**FINDINGS AND RECOMMENDATION  
OFFICE OF PLANNING AND ZONING  
ANNE ARUNDEL COUNTY, MARYLAND**

**APPLICANT:** Ricky S. Herron & Phuoc V. Le

**CASE NUMBER:** 2024-0154-V

The applicant is requesting a variance to allow a pier, platform, and pilings with less setbacks than required on property located at 2994 Valley View Road in Annapolis.

**EXISTING CONDITIONS PLAN**

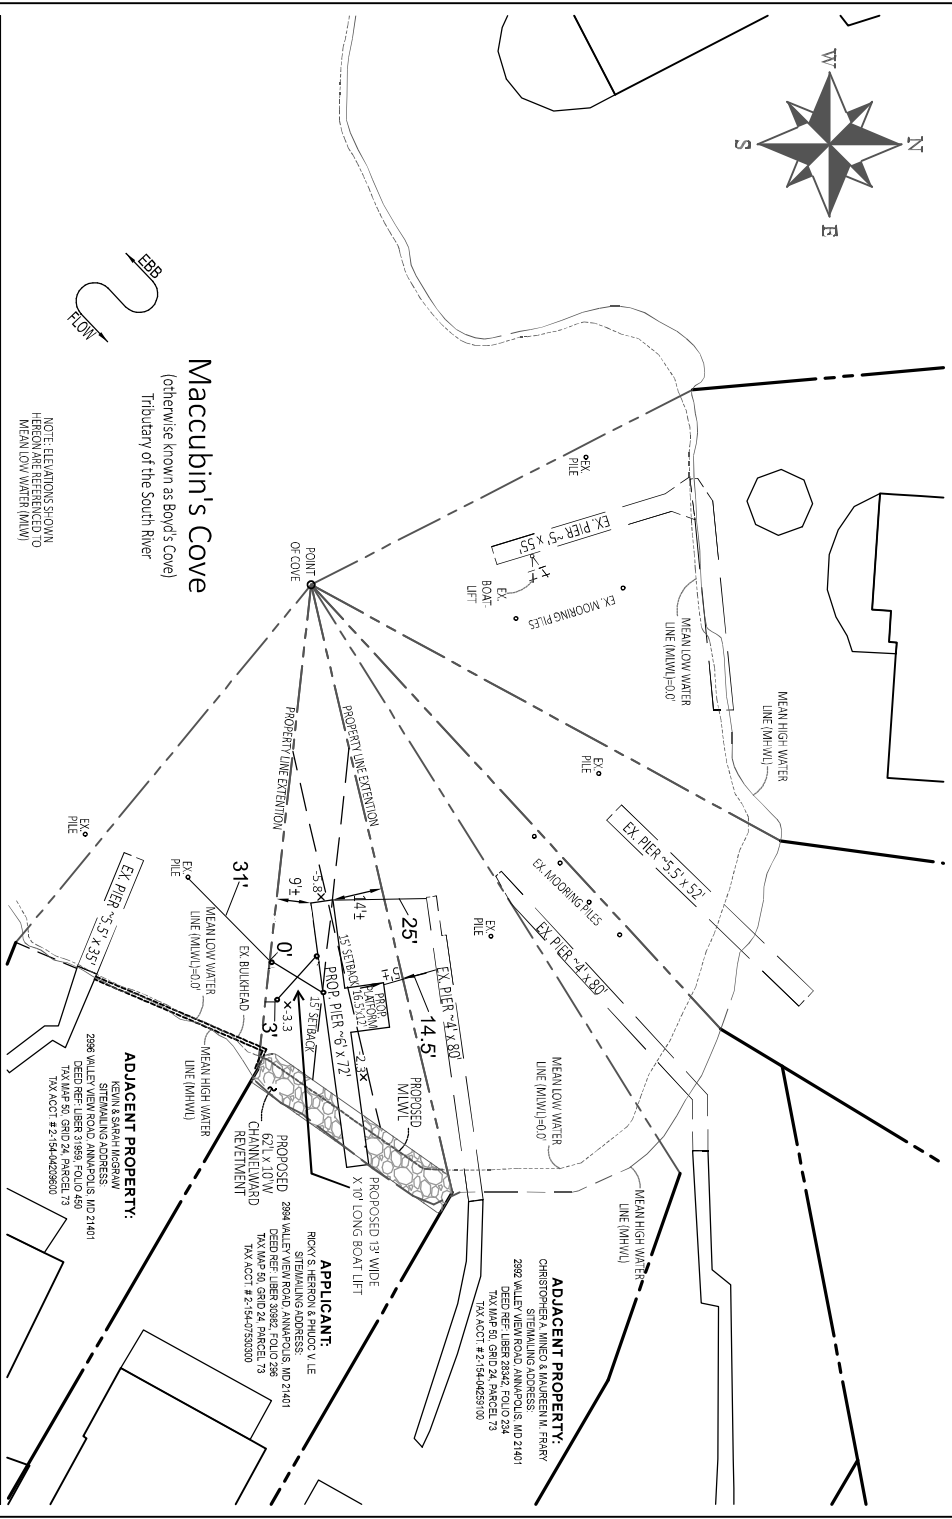
<sup>1</sup> The site plan shows a proposed 12’ by 16.5 platform. However, in line with the way that MDE measures platforms, this includes the 6’ wide pier section to which it is attached. The platform would actually measure 10.5’ by 12’.

Approval of the variance would not necessarily alter the essential character of the neighborhood or be detrimental to the public welfare. However, the variance may impair the appropriate use or development of the adjacent property to the north, as the proposed platform on the north side would intensify the pier surface congestion in this already tight portion of the cove. Taking into account the practical limitations caused by the converging lot line extensions and cove location, the request for some variance relief is justifiable. However, a pier with a boat lift on one side and a platform on the other side is excessive for this tight cove location and would provide the applicant a unique privilege that other neighbors within this portion of the cove do not have. While there are already two mooring pilings on the north side of the pier, the proposed platform would be constructed significantly further from the shoreline than the existing pilings, which would intensify the overcrowding in the area between the subject pier and the pier to the north. In line with the Critical Area Team comments, the proposed platform should be minimized or eliminated from the north side, as it is not considered to be the minimum variance necessary to allow reasonable use of and access to the water.

Based upon the standards set forth in § 18-16-305 of the Code under which a variance may be granted, this Office recommends ***modified approval*** of a zoning variance to § 18-2-404(b) to allow all proposed improvements with the exception of the 10.5' by 12' platform.
